PARTS LIST FOR WAR20N

REEL ASM. Nos. 1366200(WAR20N)

MRP Ver. 022822
(based on Penn's Rev. 2)

Penn Reel Parts list for Model: Warfare WAR20N STAR DRAG

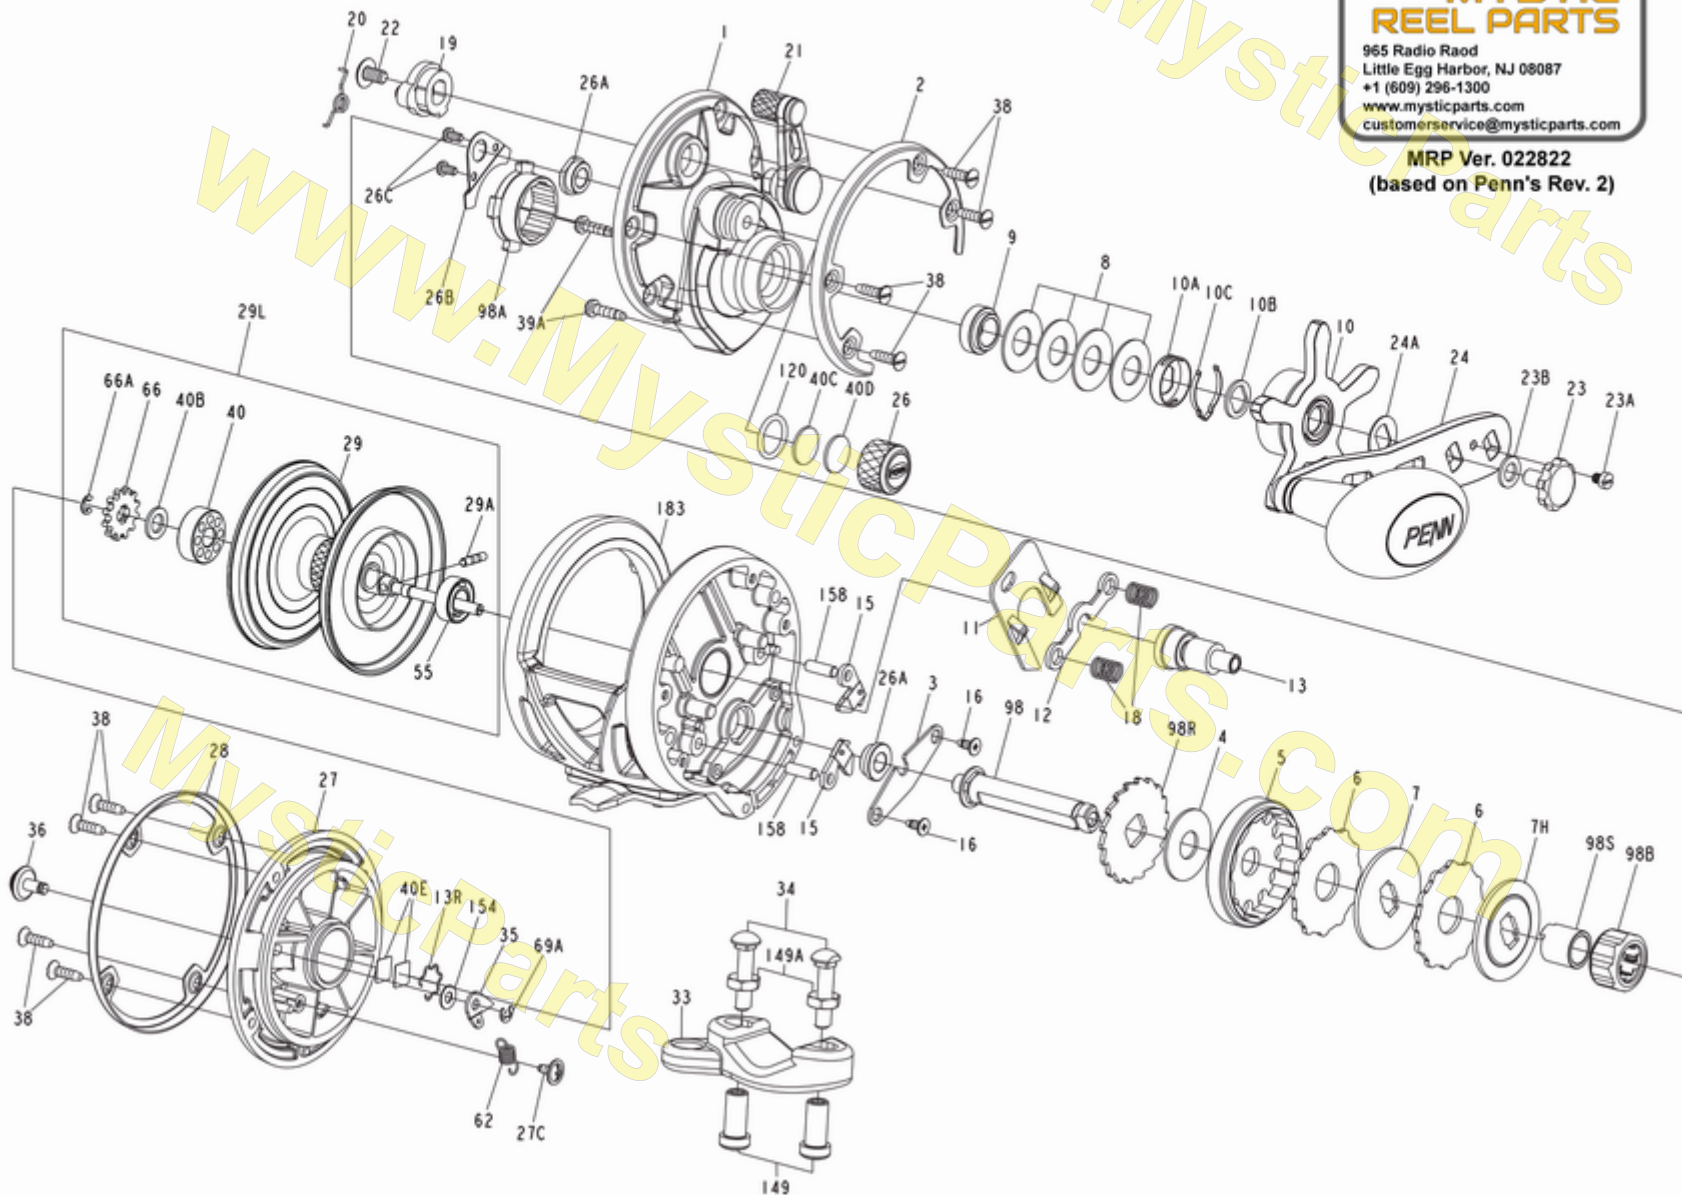
* 62 - HAD TWO KINDS 7 COIL AND 5 COIL, SEEMED RANDOM

*40B rev.0 of schematic said felt, but what was in the reels were plastic

*154 This washer shows on the schematic, but was not found in the first run WAR20N or WAR30 we examined

CLICK BUTTON ISSUE ON PENN SCHEMATICS FOR WAR20N AND WAR30 REELS

36**	1488312	36-WAR20N	CLICK BUTTON	rev 1-16-2018	36-WAR20N matches what we found in the WAR20N and WAR30 reels**
36	1383038	36-WAR15LW	CLICK BUTTON (INCORRECT!!!!)	: rev 6-4-2018	The LW button is NOT correct for these two reels.

55	1451533	55-WAR15LW	BEARING (ATTACHED TO SPOOL SHAFT)
NOTE	1191256	20-1000AF	BEARING (ATTACHED TO SPOOL SHAFT) * old key#20A (CAN BE USED IF THE 55 PART IS NOT AVAILABLE)
			We originally used 20-1000AF as the spool bearing, which wasn't on the Penn Rev0 schematic, but we now have the correct # 55-WAR15LW
29A	1451532	29A-WAR15LW	PIN TO HOLD IN SPOOL BEARING

26A	1383022	26A-WAR15LW	HOUSING BUSHING	Penn's Rev 2 6-4-2018 IS CORRECT PART
41	1383048	41-WAR15LW	BUSHING (INCORRECT PART ON PENN'S REV 0)
